ADDENDUM NO. 2

23 January 2017

RE: MILLER PARK DISTRICT PHASE 1
Contract no. R-14-011-201

FROM: Spackman Mossop Michaels / Eskew+Dumez+Ripple, Joint Venture
365 Canal Street, Suite 3150
New Orleans, Louisiana 70130
(504) 561-8686

CHATTANOOGA, TN

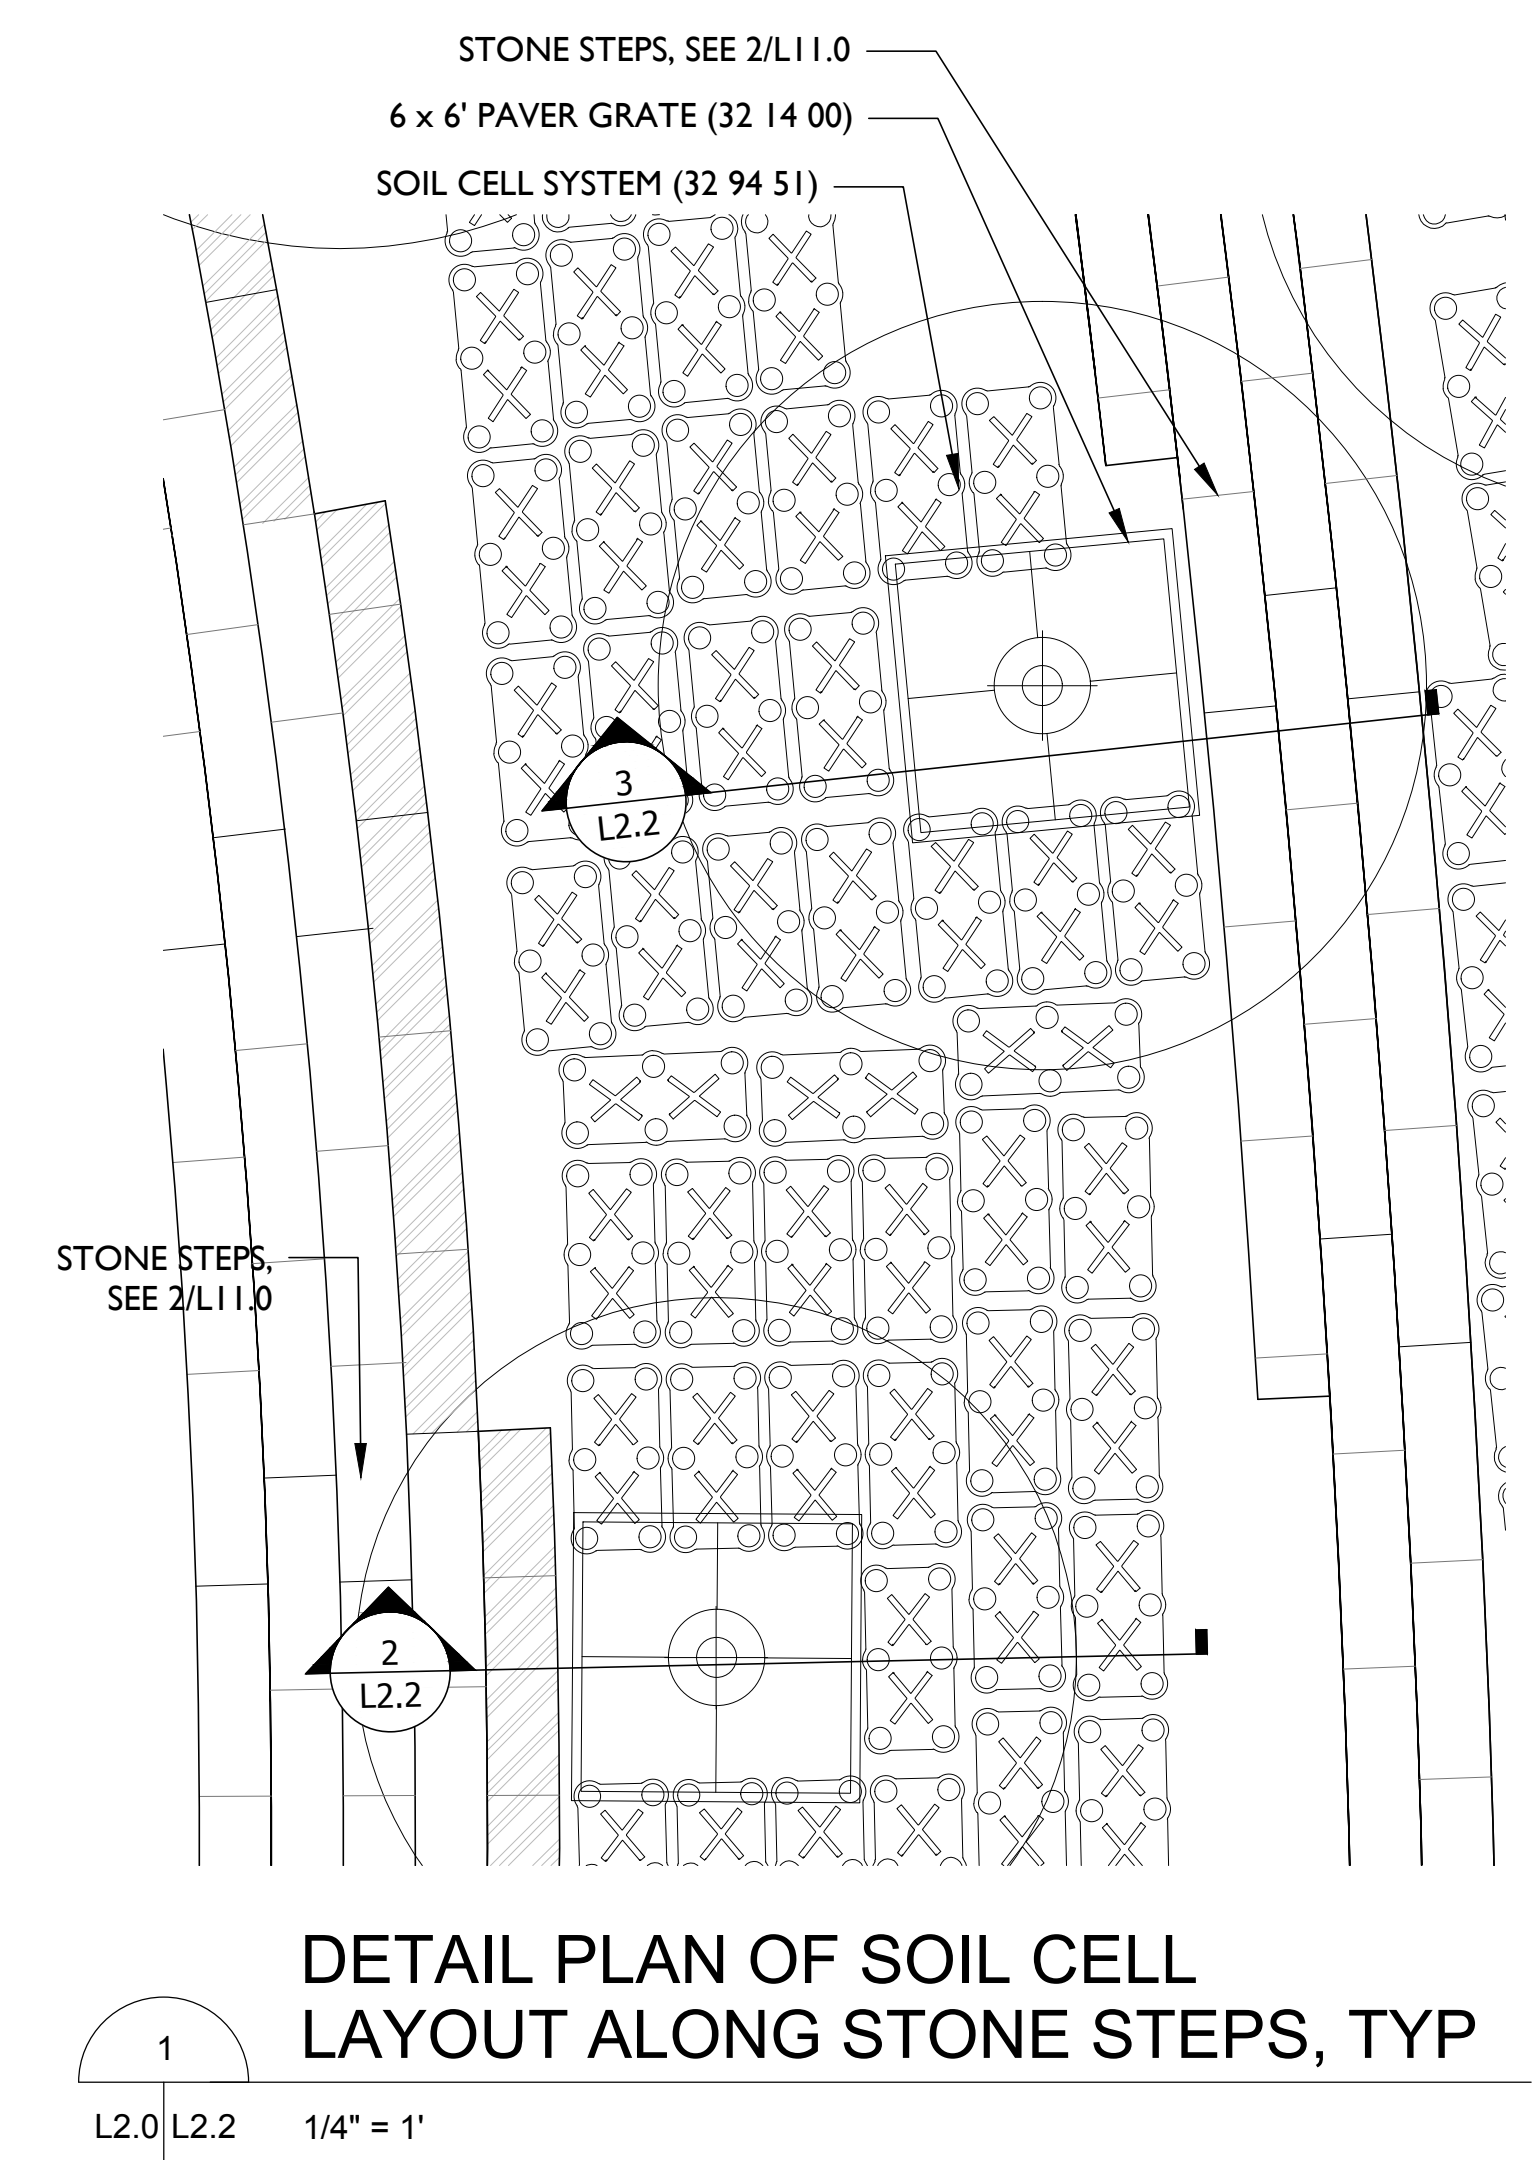
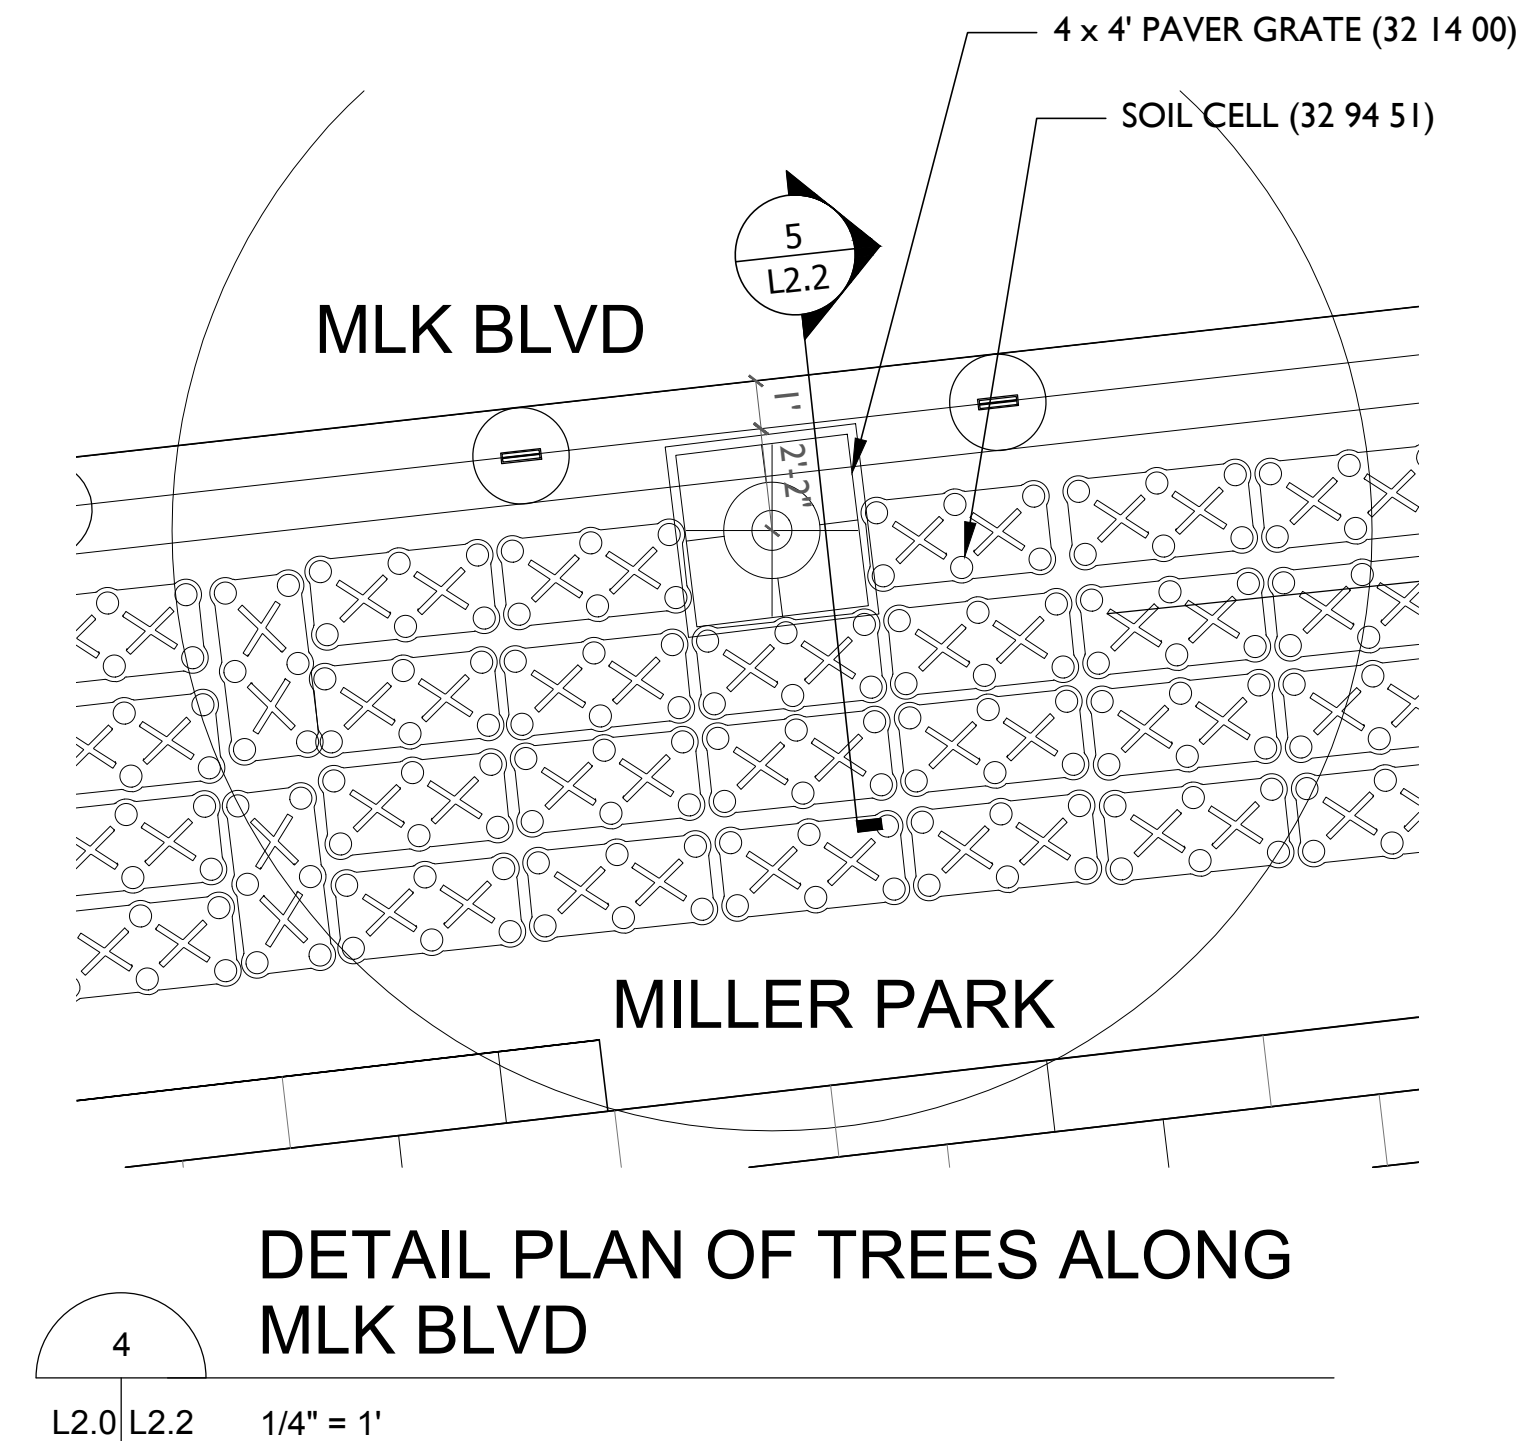
- P. L2.1- SOIL CELL DETAILS: Added title block to sheet.
- Q. L2.2- SOIL CELL DETAILS: Added 6/L2.2: Detail of Soil Cell Interaction with Light Pole and Pull Boxes.

Sheet No:
L7.8

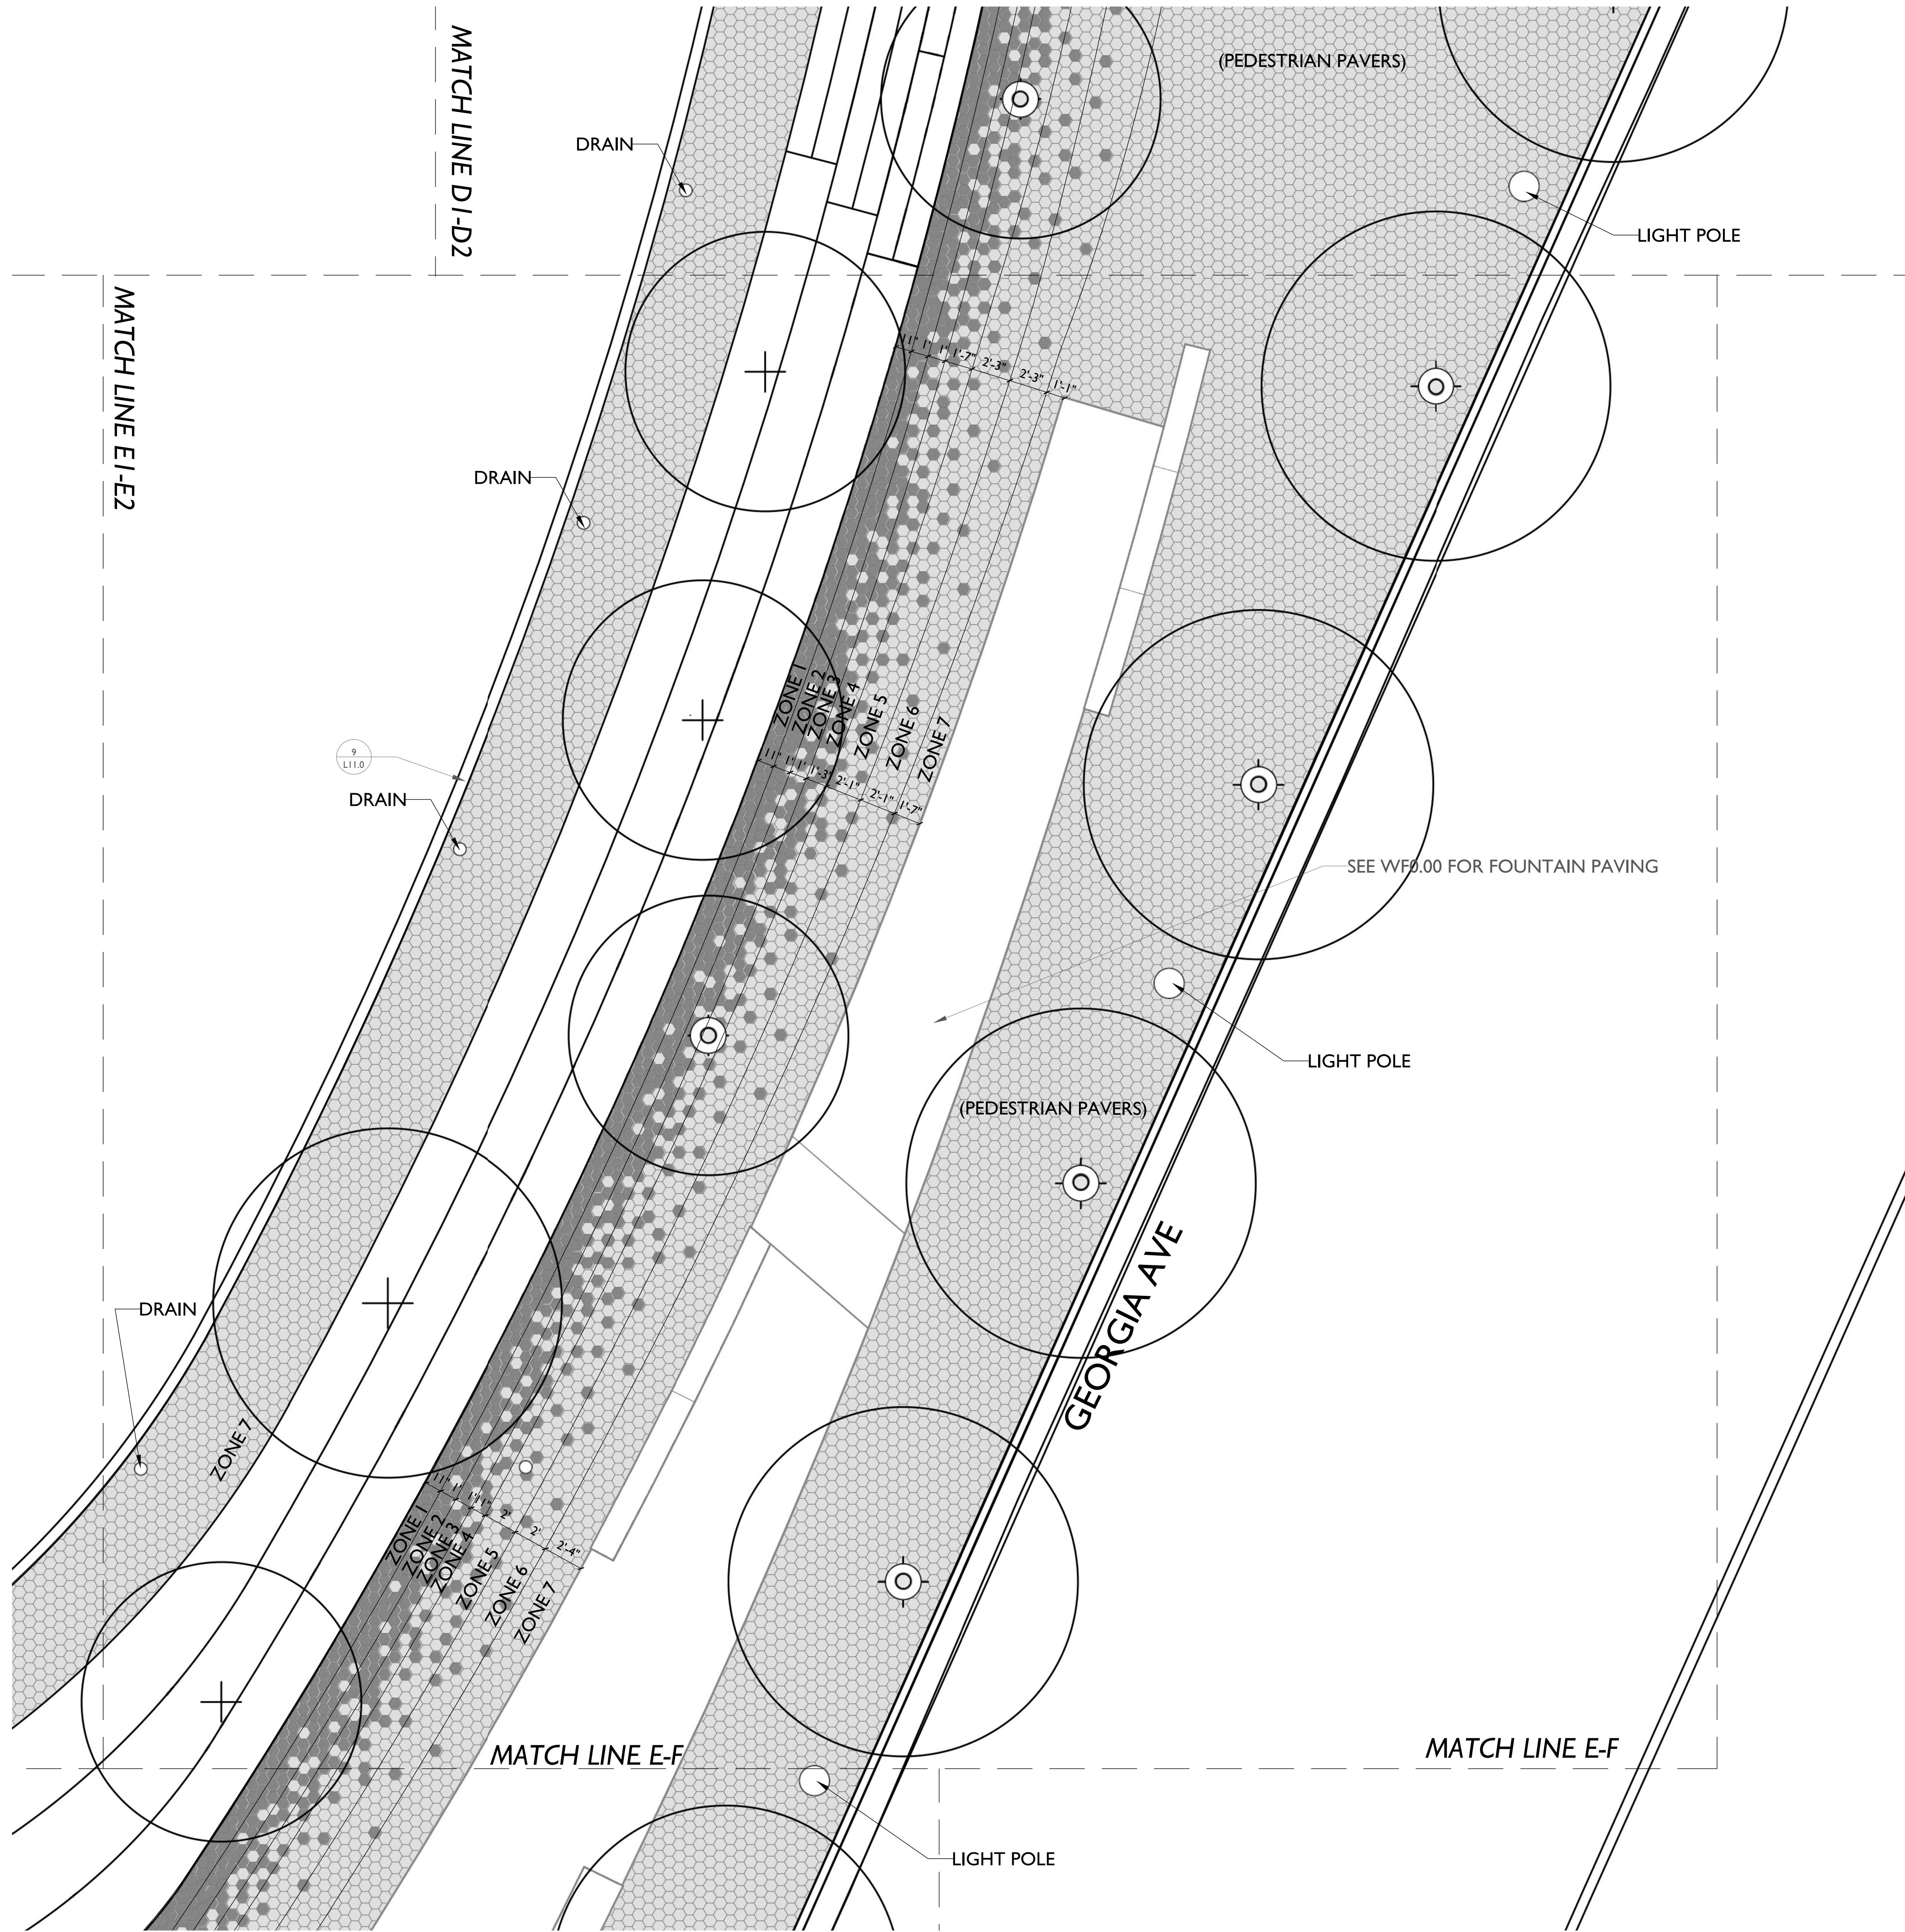
- X. L7.7- PAVING PATTERN PLAN: Added Match Lines
- Y. L7.8- PAVING PATTERN PLAN: Added Match Lines
- Z. L7.9- PAVING PATTERN PLAN: Added Match Lines
- AA. L7.10- PAVING PATTERN PLAN: Added Match Lines

6 DETAIL OF PEDESTRIAN PAVER TO LANDSCAPE EDGE AT MILLER PLAZA, TYP
L11.0 1" = 1"

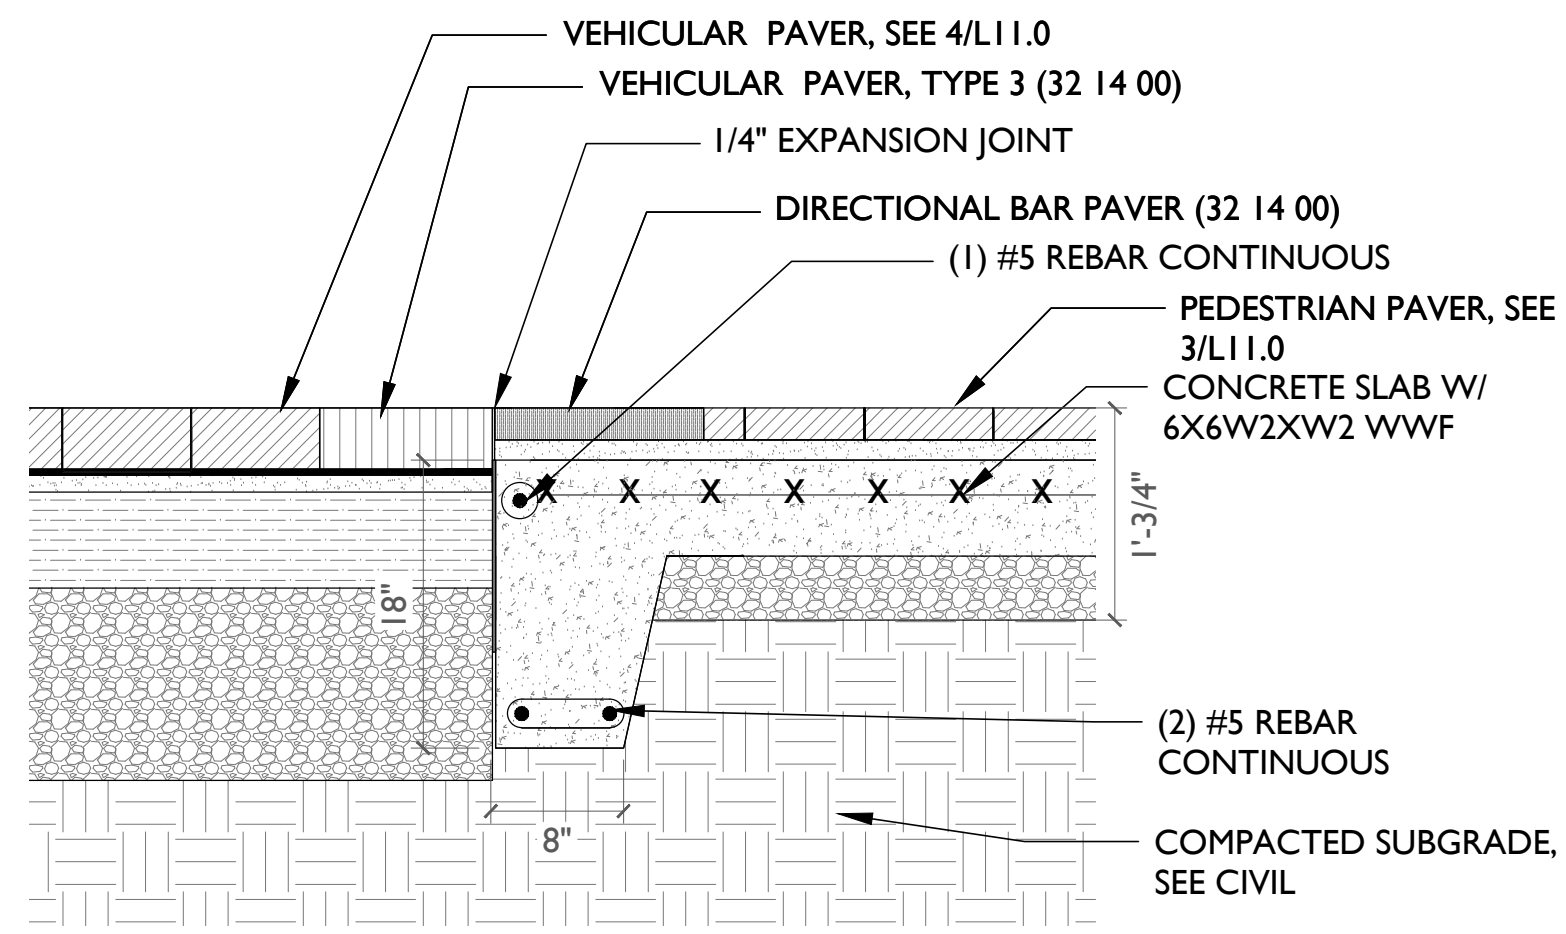
- BB. L7.11- PAVING PATTERN PLAN: Added Match Lines
- CC. L7.12- PAVING PATTERN PLAN: Added Match Lines
- DD. L7.13- PAVING PLAN DETAILS: Adjusted 1/L7.13 and 3/L7.13.
- EE. L11.0- SITE DETAILS: Adjusted 5/L11.0 and 6/L11.0
- FF. L11.1- GARDEN TERRACE DETAILS: Added detail 8/L11.1
- GG. ES1.1 Revised key notes 18 and 20. Revised location for all note 18 food truck electrical services. Adjusted city street lights along 10th street. Added "General City Street Lighting Note". Added two street lighting poles on Market Street near 10th street.
- HH. ES1.2, Revised key note 1. Added "General City Street Lighting Note".
